International Code Council

**ICC 300-2020 edition  
Public Input Agenda  
based on input received  
on 2017 edition of the  
ICC 300 Standard**

**Draft for January, 2022  
Meeting – Teleconference**

## Matrix for ICC 300 proposals

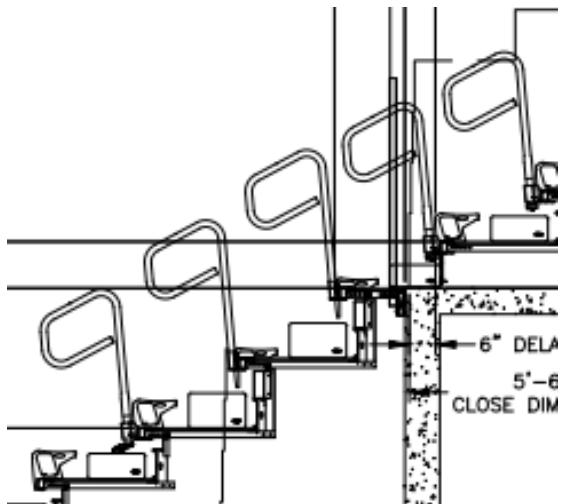
**406.8.1 Tread and riser nonuniformity permitted.** Treads and risers located in transition areas between adjacent tiered seating elements, parabolic seating configurations or onto or off of tiered seating are not required to be of uniform depth or height where a ~~mid-aisle~~ aisle handrail is provided. The handrail shall meet the requirements of Section 409. ~~Mid-aisle~~ Aisle handrails in transition areas shall extend the full length of the transition and a minimum of one tread depth, parallel to the run of the stepped aisles, above and below the uppermost and lowermost riser in the transition. Where extensions of the aisle handrail interfere with adjacent means of egress, the handrail extension shall terminate at the riser.

On Folding and Telescopic Seating, handrails that span multiple tiers prevent the operation of the bleacher with the handrail in place. Several tiers may be involved resulting in large heavy rails that require removal every time the bleacher is operated. The image below shows such a rail that would weigh in the vicinity of 35 lbs. Once removed, there is no guarantee that the attachments used to hold the rail to the bleacher will return to the exact location making reinstallation extremely difficult (if not impossible).

By putting the rails and attachments on individual tiers, the rail are lighter and the attachments are not required to repeatedly line up with other moving tiers.

CROSS BAR IS LOCATED TO STOP  
PASSAGE OF A 4 INCH SPHERE  
WHEN THE 34 INCH IS MEASURED  
TO THE TOP OF THE SPHERE.

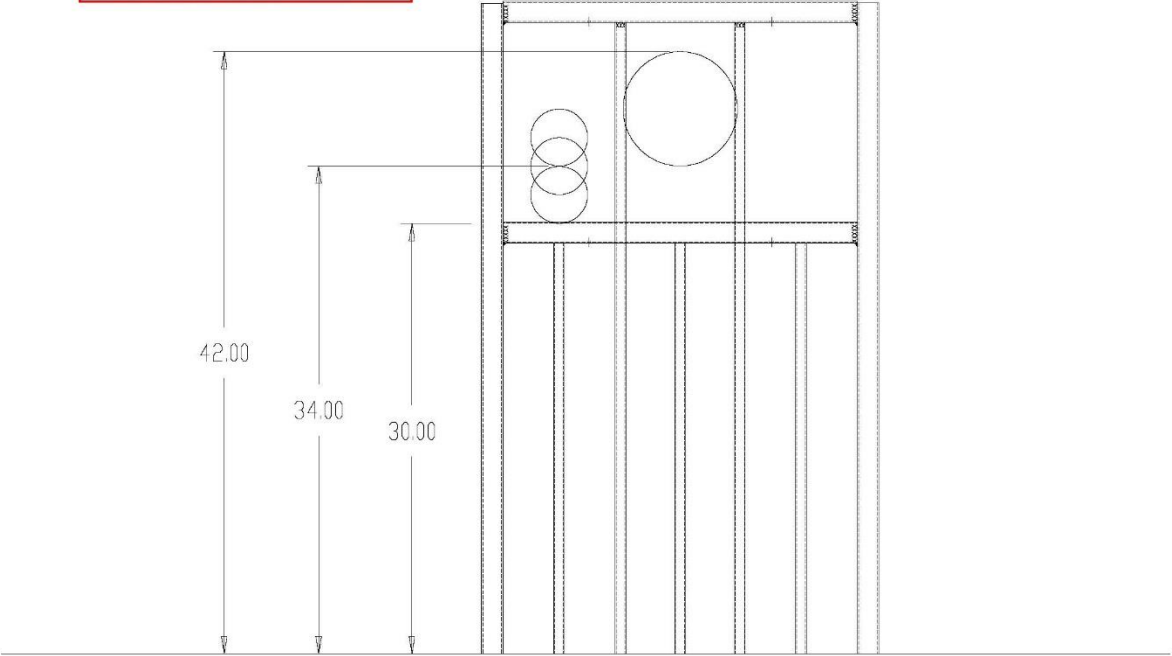
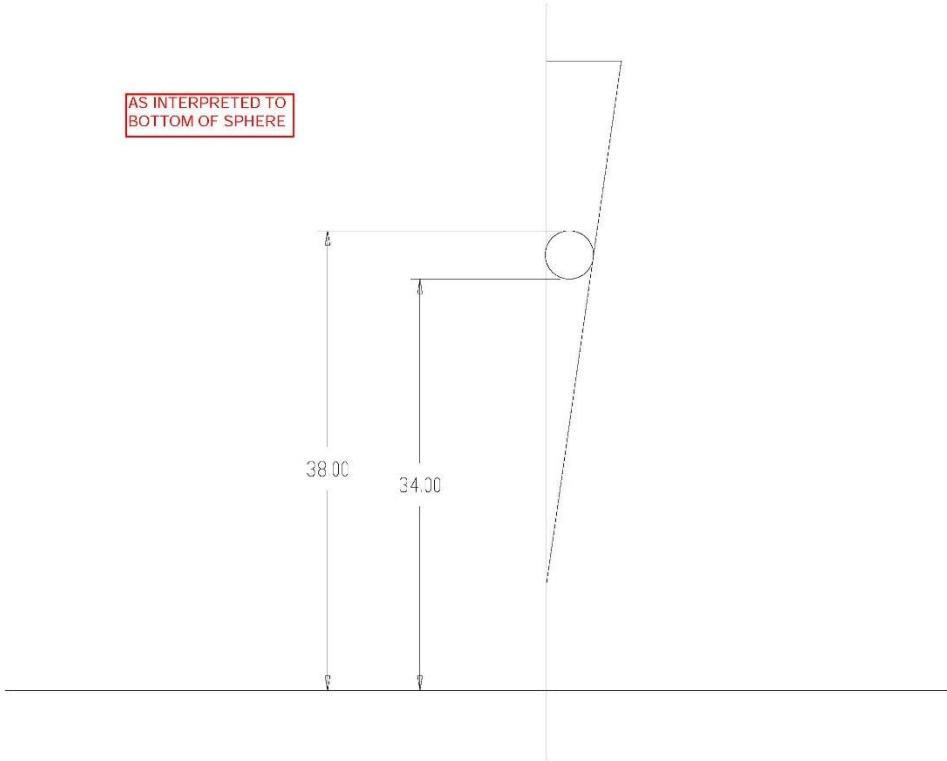
**Reason:** This proposal assumes that my proposal for revision to section 408.1 is approved. The lower reference is clarified from “the adjacent walking surface” to the enumerated references of the revised 408.1. Adding “to the bottom of the sphere” locates the height of the sphere. Per figure 1 which follows, the cross bar could interpreted to be as low as 30 inches. By adding “to the bottom of the sphere”, the minimum cross bar height is clarified to be 34 inches. I believe that was the original intent.

Figure 2 which follows shows a situation somewhat common in telescopic seating because the guards slope away from the seating for the purpose of making them nest in storage or retraction. If the height of the sphere is not defined, one may not be able to accurately say if an opening is compliant or not.

The 42 inch height in the original requirement has no meaning. Rail heights are allowed to exceed that height and often do as shown in figure 1. I believe the intent is to stop the 8 inch sphere as high up as the rail goes.

AS INTERPRETED TO  
BOTTOM OF SPHERE

**408.2 Opening limitations.** Open guards shall be constructed of materials such that a 4-inch-diameter (120 mm) sphere, cannot pass through any opening up to a height of 34 inches (864 mm) measured vertically in accordance with Section 408.1 to the bottom of the sphere. ~~From Above~~ a height of 34 inches (864 mm) ~~to 42 inches (1067 mm)~~ above the adjacent walking surfaces, a sphere 8 inches (203 mm) in diameter sphere shall not pass.

**Figure 3** Rod Laver Arena in Melbourne, Australia

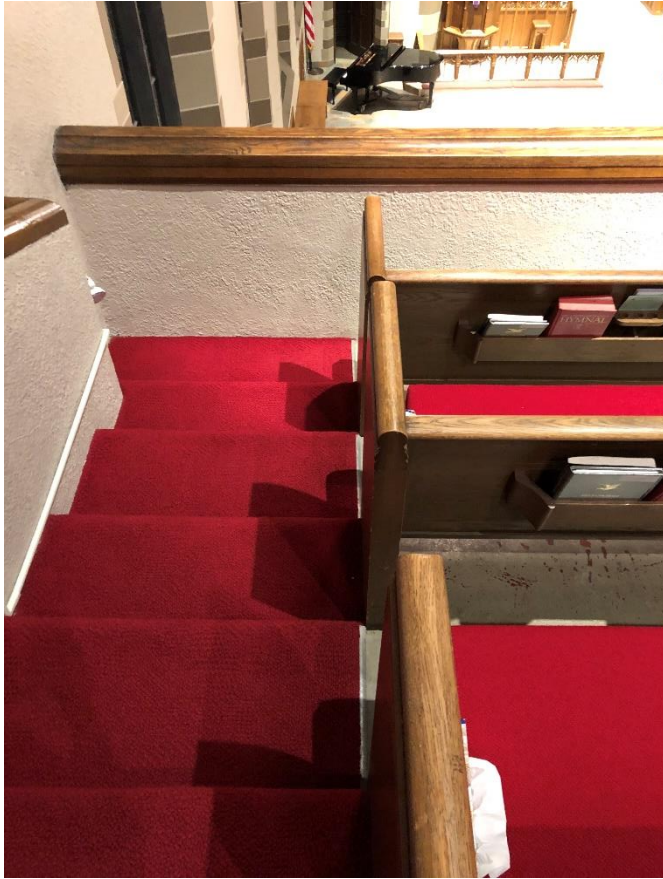
A new section has been added for handrails adjacent to seats. For examples, see figures 2 through 6. Handrail systems adjacent to seats are more commonly used in steeper seating found in balconies and upper tiers where providing fall arrest is critical. Use of a knob as an individual handrail is proposed. An example is shown in figure 4. The doorknob industry standard dimension information is provided in figure 6.

**409.1.3 Handrails Adjacent to Seats.** Handrails in stepped aisles adjacent to the end seats in a row shall provide gaps or breaks between handrails at access aisles to facilitate access to the aisle. The gaps shall have a clear width not less than 22 inches (559 mm) and not greater than 36 inches (914 mm) measured horizontally. The front and back edges of the handrail shall not extend beyond the front and back

**Figure 10**

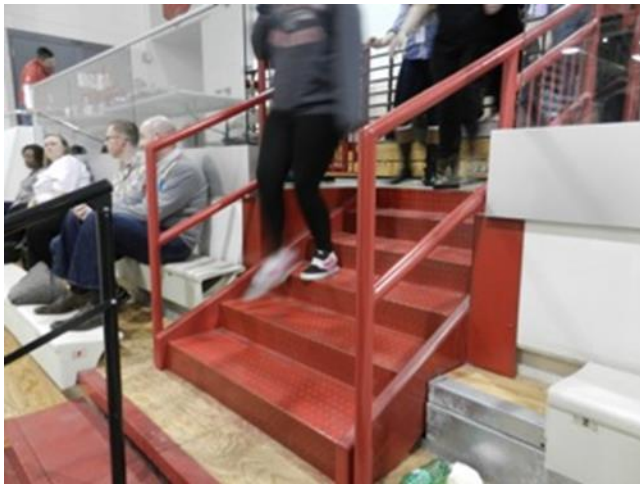
**Reason:** An aisle can have seating on both sides in one portion of its length, seating on one side in another and seating on neither side in still another. See figures 1, 8, 9 and 10. Wording has been modified to capture requirements in each area separately.

A handrail placed at the sides of a stepped aisle is effective when placed at the transition onto or off of tiered seating. This type of rail is shown on the back cover of ICC 300-2017 and Figures 8 and 10. The new text also provides for a single mid-aisle rail as shown in figure 9. On narrower aisles, where seating above is on only one side and the aisle width is allowed to be less than 48 inches (as low as 36 inches). On these narrow aisles extensions where there seating on neither side, an allowance is made to provide a continuous handrail on one side only. Being so narrow it is not likely people will be egressing down both sides of the aisle.

**409.2.1 Portions of stepped aisles with seats on both sides.** Portions of stepped aisles with seats on both sides shall be provided with a minimum of one mid-aisle handrail.

**409.2.2 Portions of stepped aisles with seats on one side.** Portions of aisles with seats on one side shall be provided with a minimum of one continuous handrail on the side of the aisle where there are no seats.

**409.2.3 Portions of stepped aisles with seats on neither side.** Portions of stepped aisles with seats on neither side shall be provided with continuous handrails on both sides of the aisle.

First United Methodist Church in Kalamazoo, Michigan

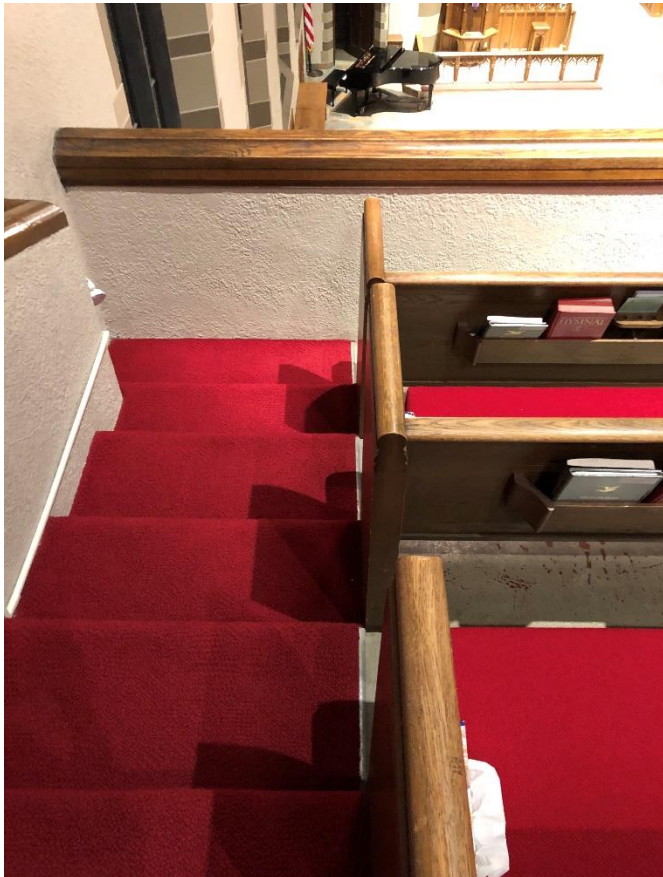
**Reason:** This proposal picks up the handrail graspability options in IBC Section 1014.3. This is based on recent studies sponsored by the Stairway Manufacturers Association.

**Exception:** Where the handrail is the end cap of pew type seating, handrails shall be in accordance with Section 409.3.1, 409.3.2 or shall provide equivalent graspability.
